Re: Former Chevron Service Station No. 9-1026
3701 Broadway
Oakland, CA

Re: Work Plan Addendum
Former Chevron Station #9-1026
3701 Broadway
Oakland, California
Fuel Leak Case No. RO0500

Subject: Request for Work Plan Addendum; Fuel Leak Case No. RO0000500 (Global ID # T0600100334), Chevron #9-1026, 3701 Broadway, Oakland CA 94611

Figure 2
EXPANDED SITE PLAN WITH UTILITIES AND CULVERT
FORMER CHEVRON STATION 9-1026
3701 BROADWAY
Oakland, California

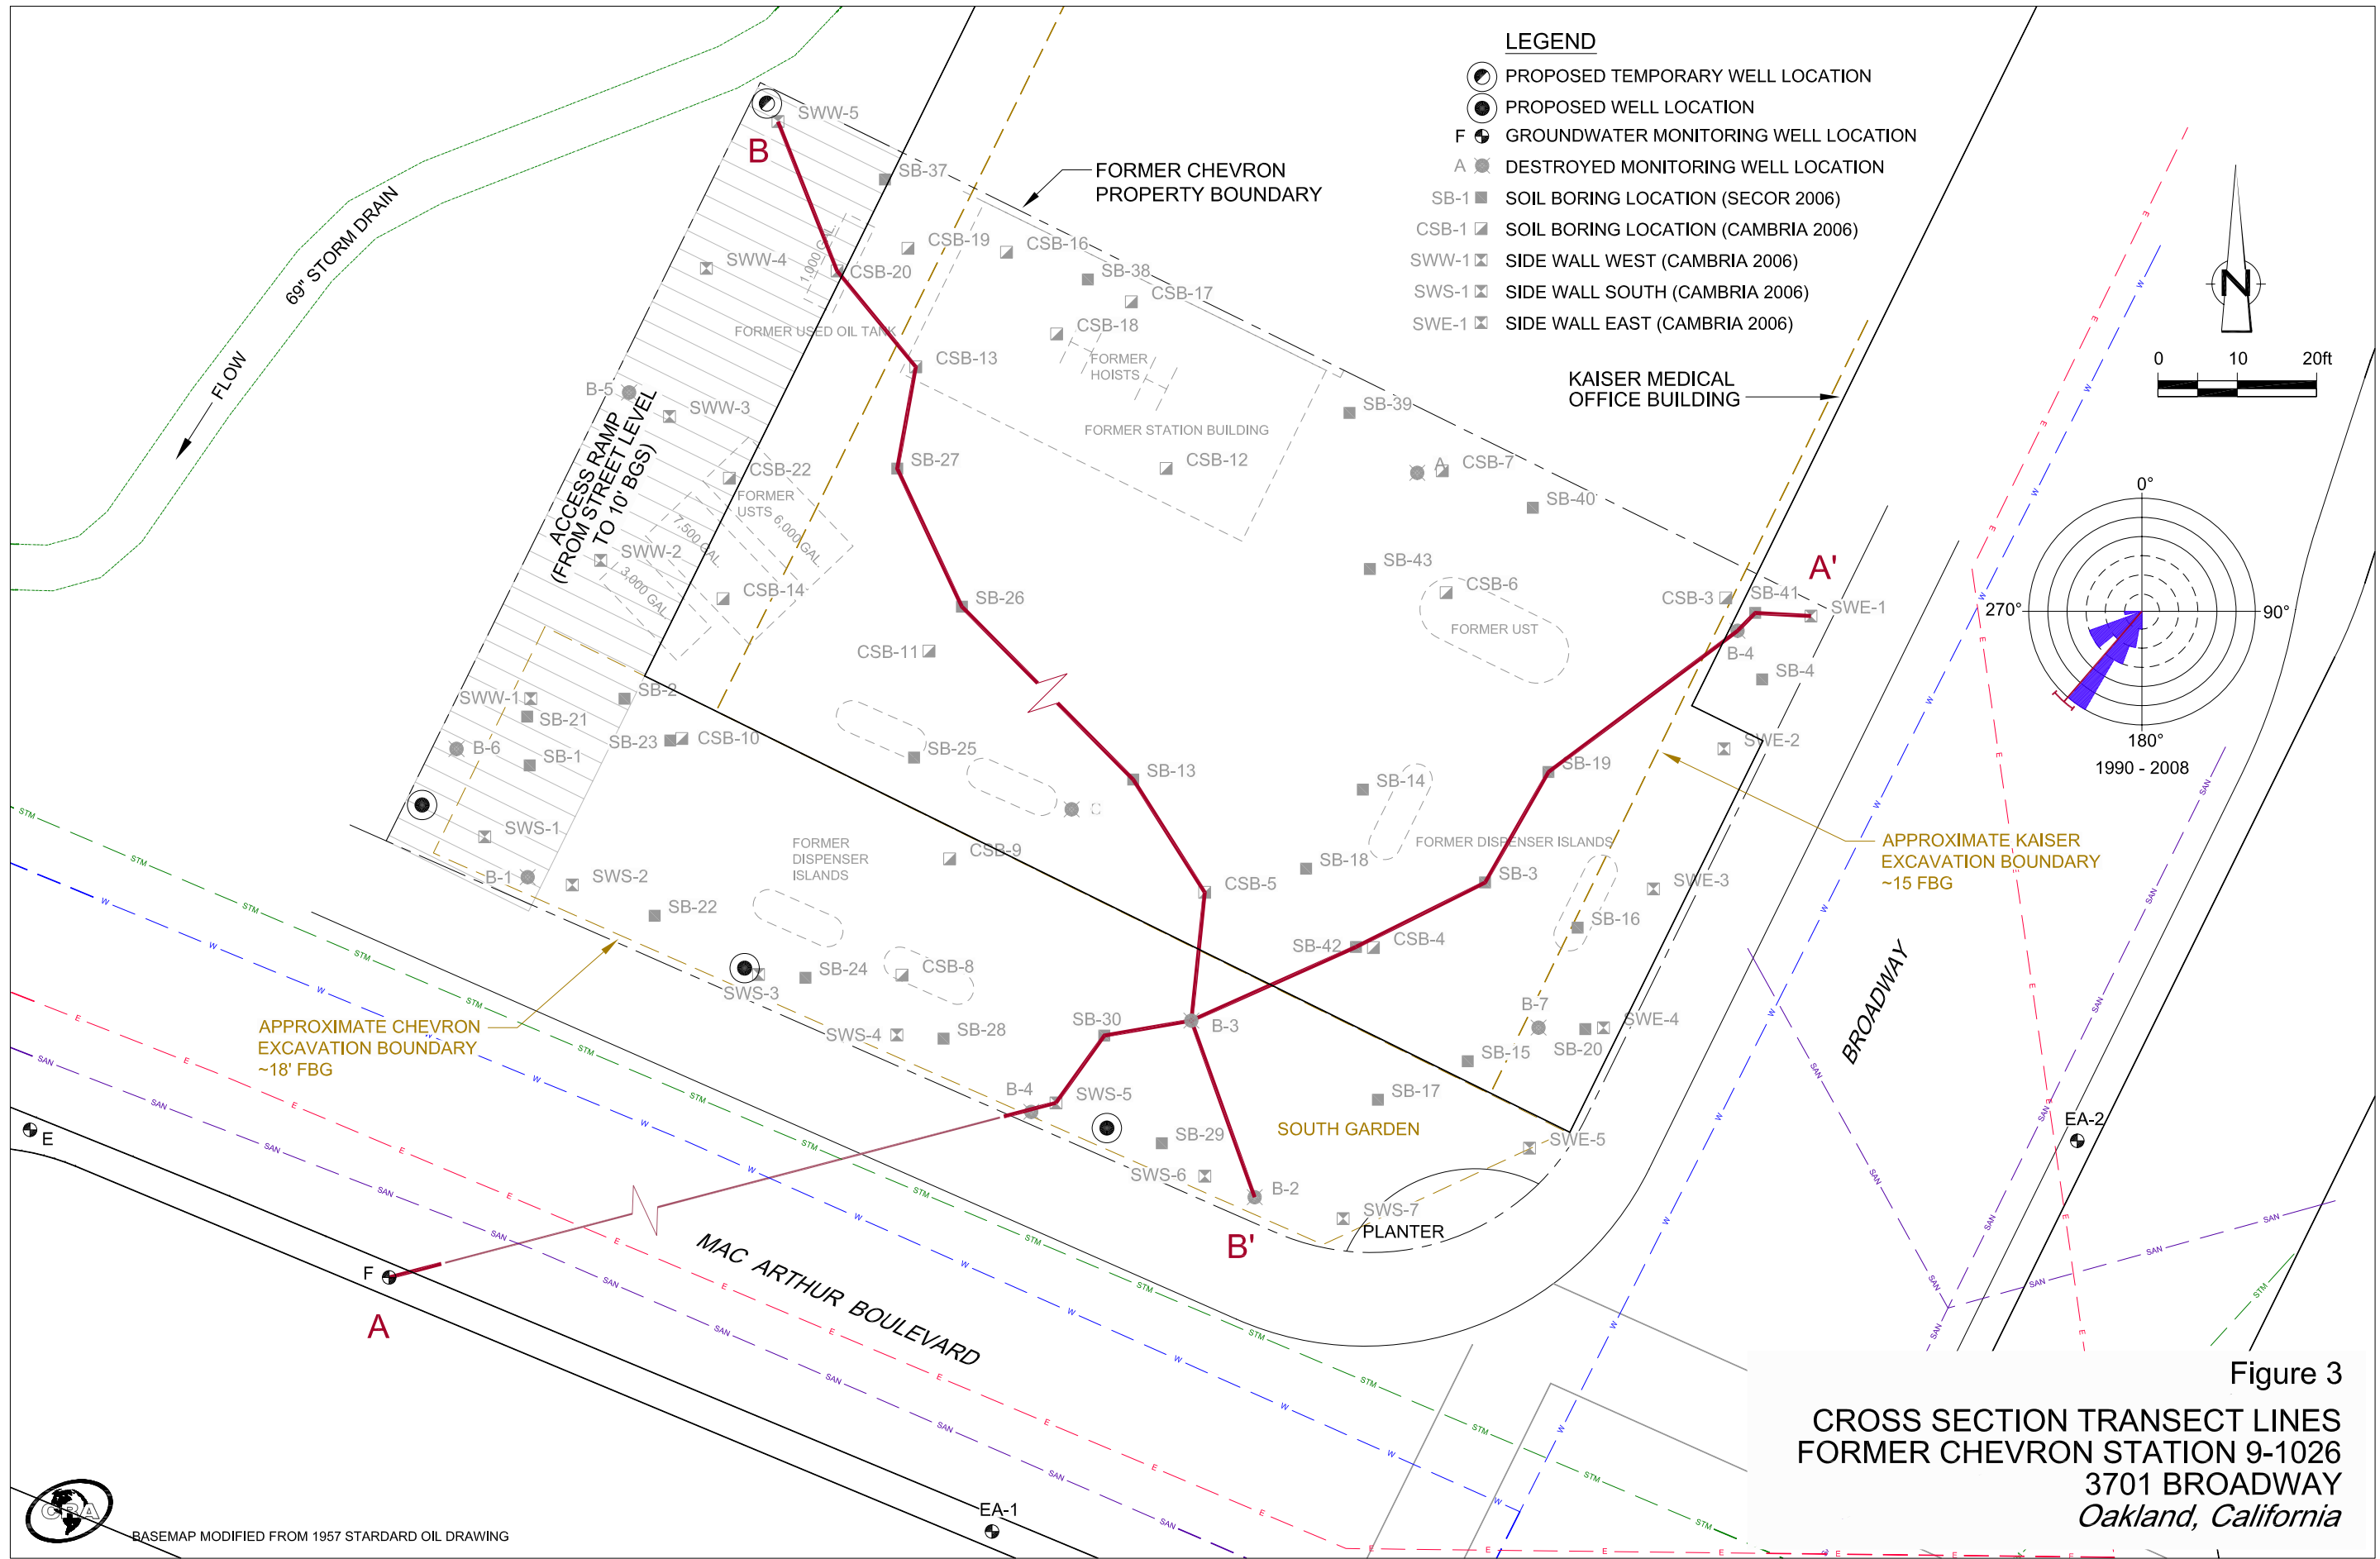
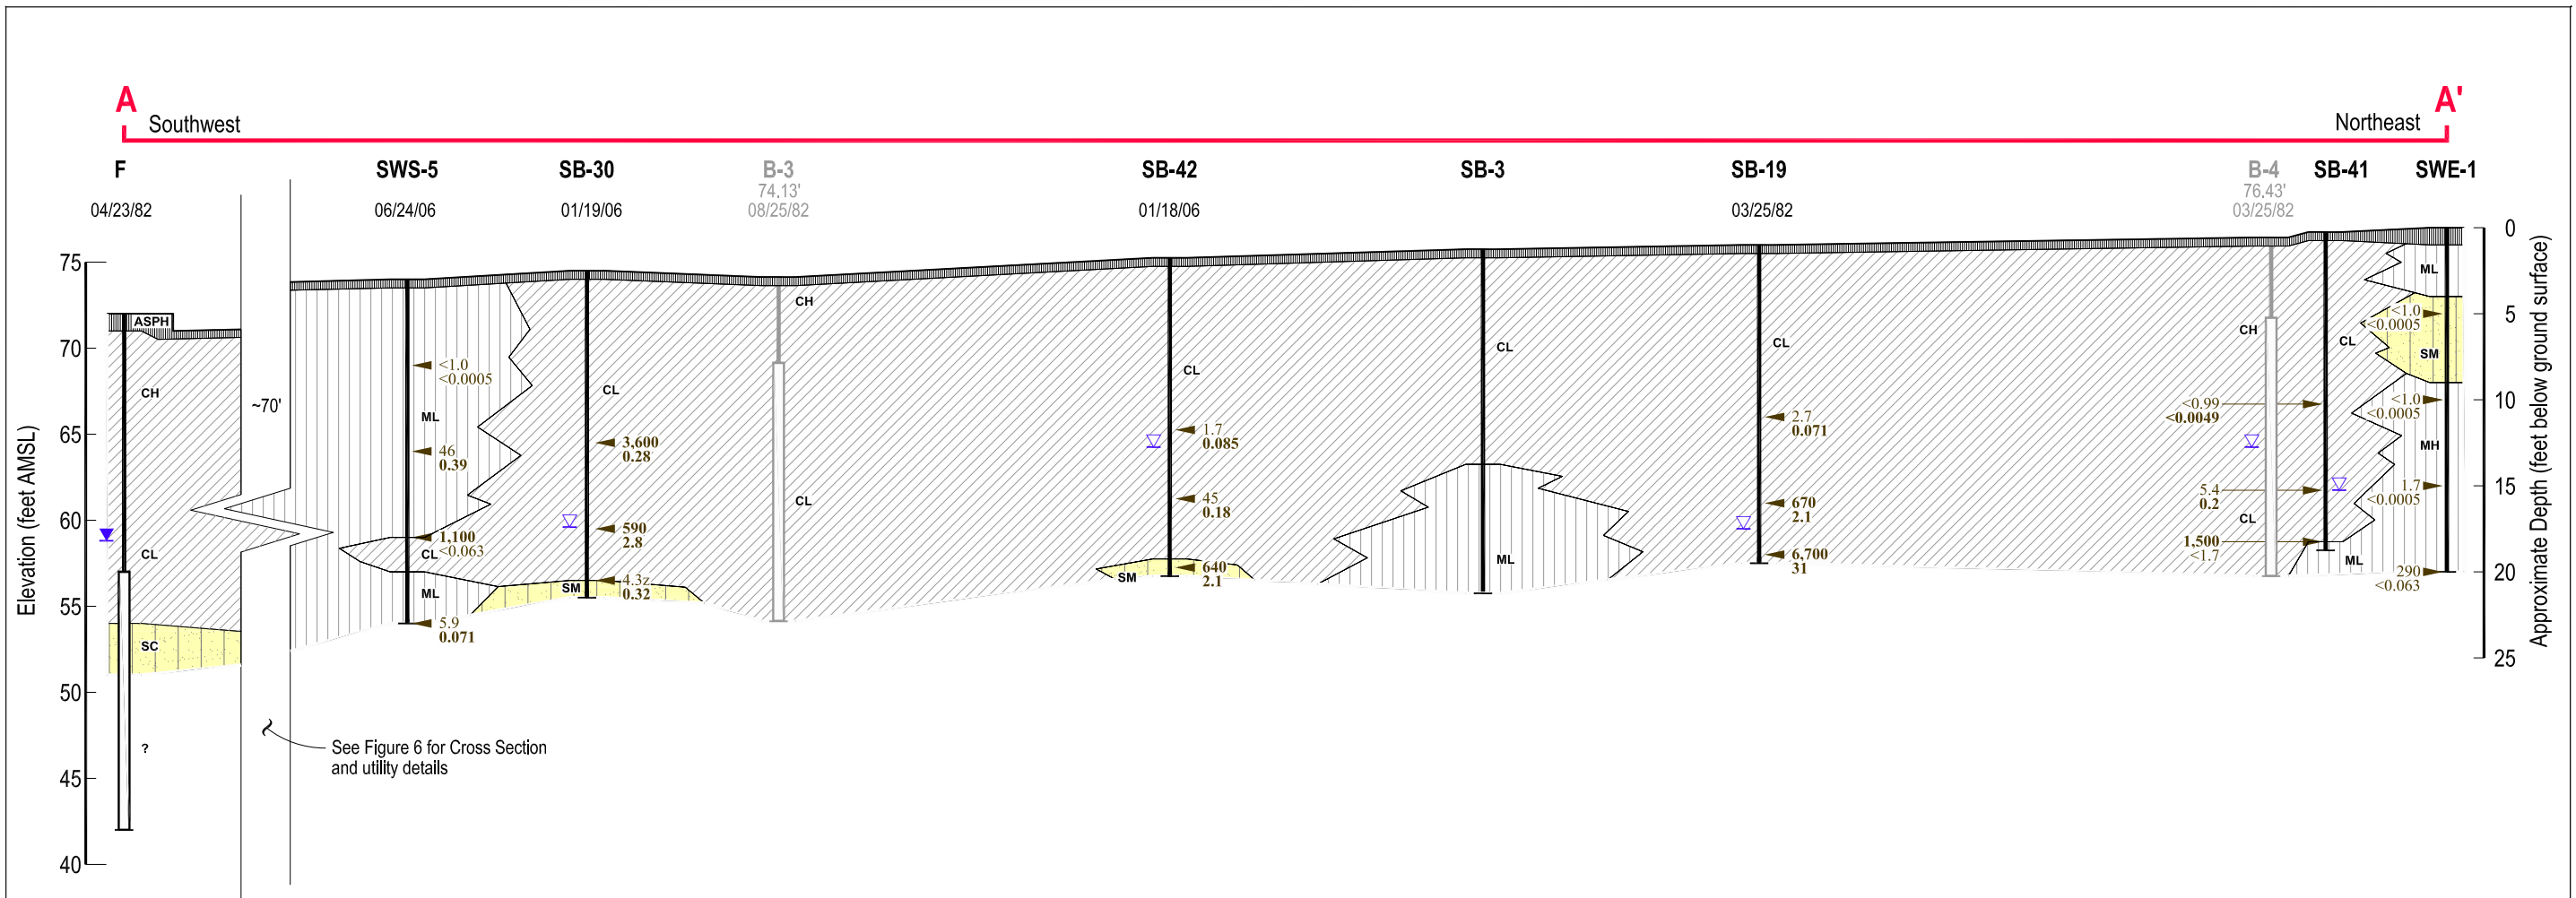
- a. The proposed locations are stated to be tentative and are expected to be placed depending upon utility and other considerations. ACEH must be in agreement with the final proposed well placement prior to installation. Please provide those locations in the Work Plan Addendum requested below.

- c. The location of a temporary well proposed to investigate flow of contaminants to the storm drain from the site in the vicinity of soil bore / sidewall sample SWW-5 did not appear on the final version of Figure 6 (proposed well locations). Please include it in a figure of final locations for the permanent wells in the document requested below. ACEH also requests the completion of a two additional temporary wells:

- i. One in remaining native soils at the western corner of the site in the vicinity of former well B-6 to investigate downgradient migration of hydrocarbons towards the storm drain west of the site. A review of older groundwater data and flow directions from wells B-1 and B-6 suggest this possibility should be investigated.

- ii. One in remaining native soils east of the Kaiser Medical Office Building between the building and the sidewalk along Broadway to investigate the downgradient transport of dissolved hydrocarbons potentially emanating from the subject site.

- iii. Please include the final locations in the Work Plan Addendum requested below.
- d. ACEH has also reviewed historic groundwater flow direction maps contained in the online case files and located more than a few that do not appear to have been used in the generation of the rose diagram that appears on multiple figures. These indicate a southeastern flow direction has existed in at the site. It appears warranted to investigate flow towards the southeast and requires the installation of offsite wells to investigate such a possibility. Please note that wells E, F, EA-1, and EA-2 have 15 to 25 foot screen intervals, were not logged between 20 to 30 feet bgs (wells E and F), and may potentially join multiple water-bearing zones (EA-1 and EA-2); reliability of groundwater data generated at these wells can reasonably be argued to be suspect. Please include the final locations, and rationale for the locations and well design in the Work Plan Addendum requested below.

- a. Site plans with the approximate locations of known utilities, the South Garden area adjacent to MacArthur, the onsite building locations, excavation locations and depths, and the proposed onsite well locations are included as Figure 2. CRA will attempt to install the monitoring wells as close to the proposed locations as possible, as long as no unexpected underground utilities, debris, or other logistical obstructions are encountered.

- c. The location of the proposed temporary well in the vicinity of soil sample SWW-5 is presented on Figure 2.
 - i. The previously proposed monitoring well near boring SB-2 has been moved near former well B-6 in the southwest corner of the site, downgradient of the former gasoline underground storage tanks (USTs).

- ii. Due to the medical office building, walkways, stairwells, utilities and underground vaults, a well on the east side of the Kaiser building could only potentially be installed in the sidewalk, provided there are no utilities. Since groundwater flow is to the southwest and well EA-2 currently monitors groundwater in this upgradient area, a well is not warranted at this location

- iii. Locations of the proposed wells are indicated on Figure 2.
- d. Groundwater flow beneath the site has consistently been to the southwest. A review of all available groundwater monitoring reports in CRA's files and in the ACEH website located a total of 46 calculated flow directions. Forty-two monitoring events (from 1990 to 2008) were used in the rose diagram (Figure 2) and all calculated groundwater to flow toward to southwest. Three monitoring events from 1989 and one event from 1990 were not used in the rose diagram because the flow directions were calculated using estimations inferred from the topography of the site (due to lack of TOC survey), and are therefore unreliable.

Figure 4
GEOLOGIC CROSS SECTION A-A' PRE-EXCAVATION 2008
FORMER CHEVRON STATION 9-1026
3701 BROADWAY
Oakland, California

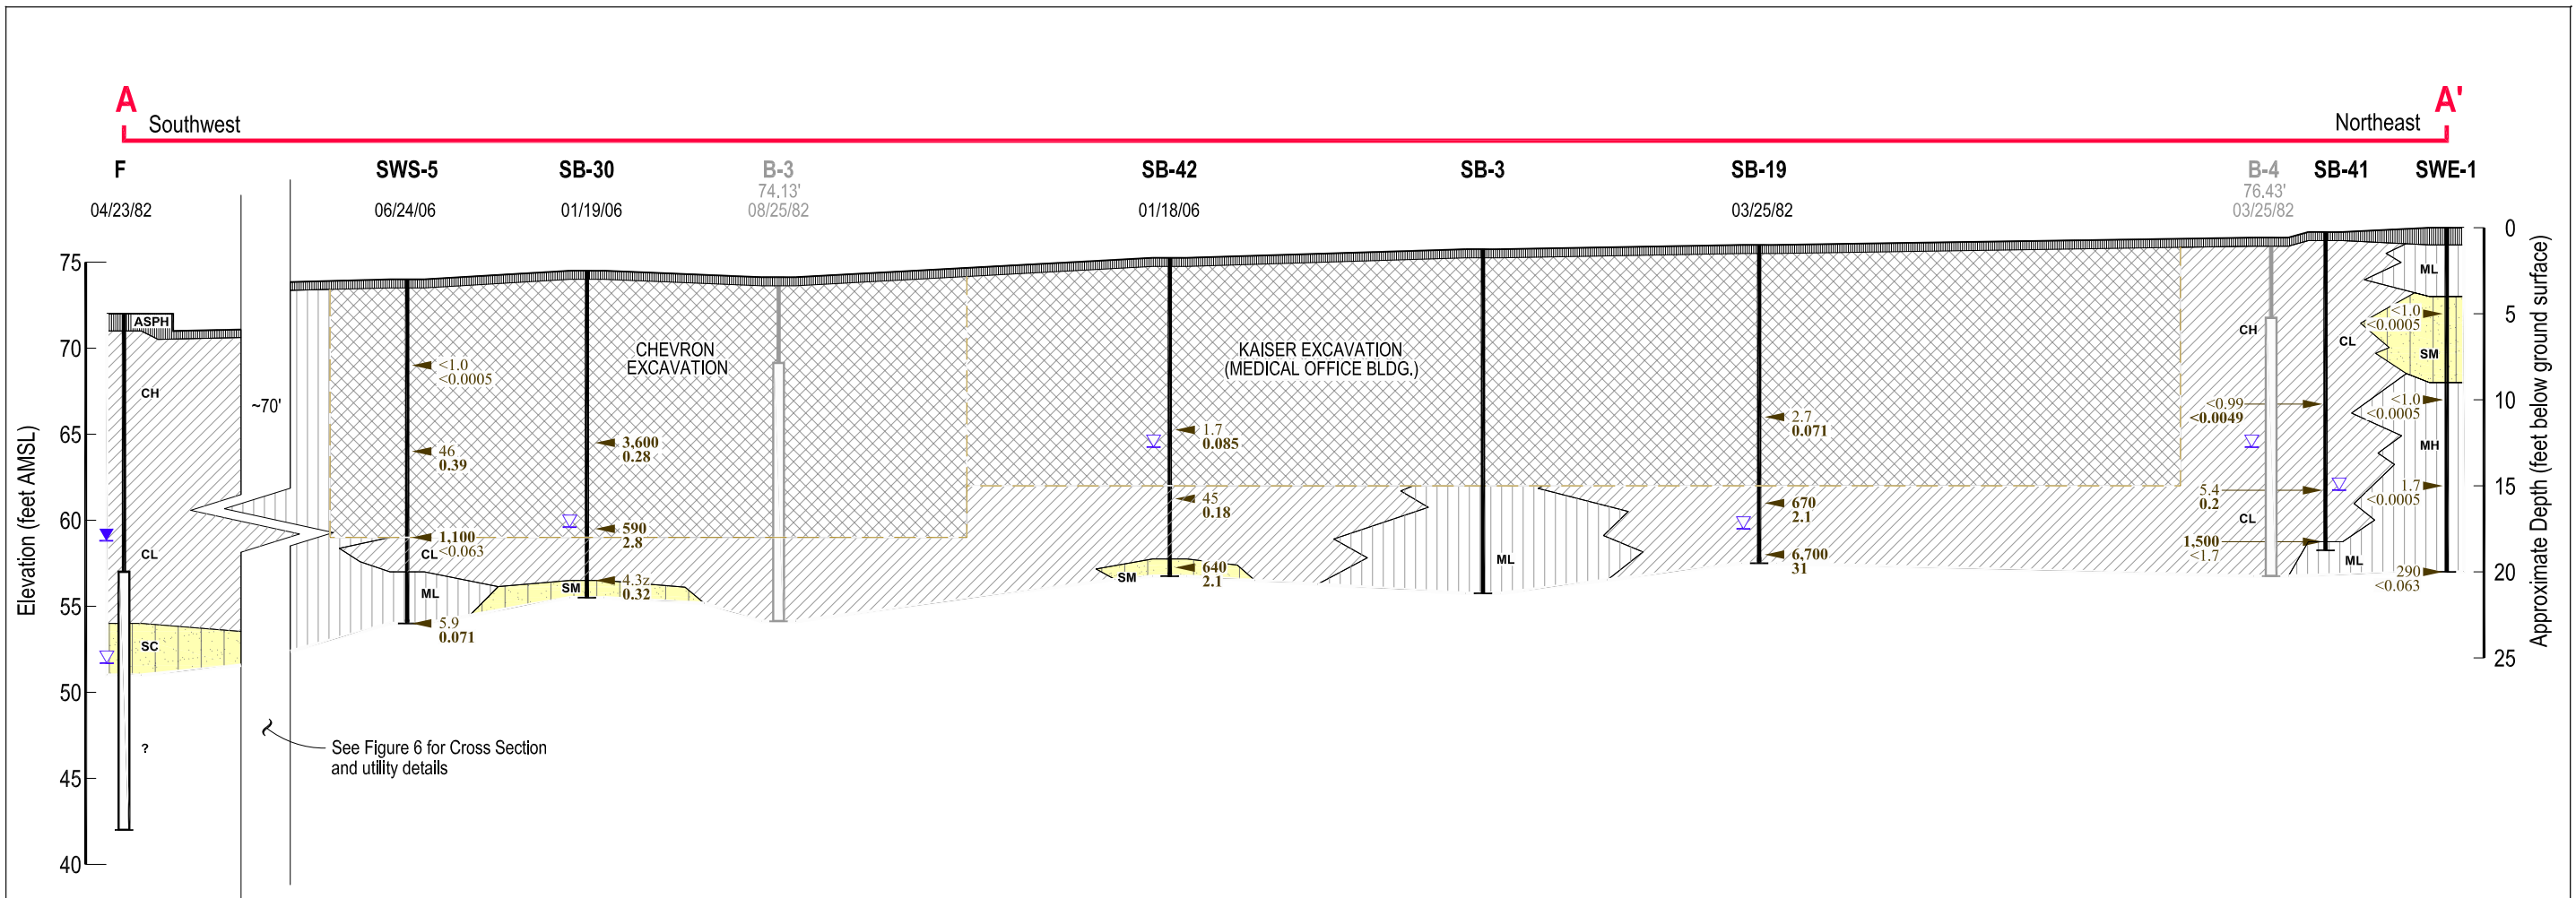
- b. Pre-excavation soil bores generally suggest two potential water bearing zones can be present in the upper 20 to 21 feet bgs at the site, one at approximately 8 to 12 feet bgs, and another varying between approximately 16 to 21 feet bgs (Please note correlations

are somewhat tentative; no site cross-sections have been located for the project). The interval at approximately 8 to 12 feet bgs contains indications of intermittent flow; due perhaps to rain or other temporary infiltration along an overbank splay originating from the westward deflection of Western Creek, now a channelized storm drain, at the northwest corner of the former Chevron parcel. In general, ACEH recommends the use of monitoring wells designed with sand pack intervals of 5 feet or less; as these wells will likely be representative of depth discrete groundwater conditions. Because the area of backfill will largely act as a basin intercepting groundwater flow from these two depth intervals, it may be appropriate to link the two zones for the proposed wells closest to the Macarthur sidewalk (i.e. to monitor the overexcavation backfill basin as a single unit). For the well closest to the former UST basin, it appears the well will be installed in native soils; consequently a more appropriate short well screening interval should be identified prior to well installation. ACEH requests the generation of a minimum of two cross sections, one parallel and one perpendicular to the predominate direction of groundwater flow, prior to well installation using pre- and post-excavation elevations. Please include these cross sections, or any additional sections deemed appropriate in the Work Plan Addendum requested below. Please include utility corridors or other known preferential pathway in the cross sections (see below).

- b. Cross-sections illustrating site lithology, well screens, and underground utilities beneath MacArthur Boulevard are included as Figures 3 through 8. A review of site boring log data reveals one water-bearing zone of silty and clayey sands beneath the clay at depths of approximately 18 to 20 fbg (Figures 3 through 8). After the confined water-bearing zone is penetrated, static groundwater in the wells rises to approximately 12 fbg.
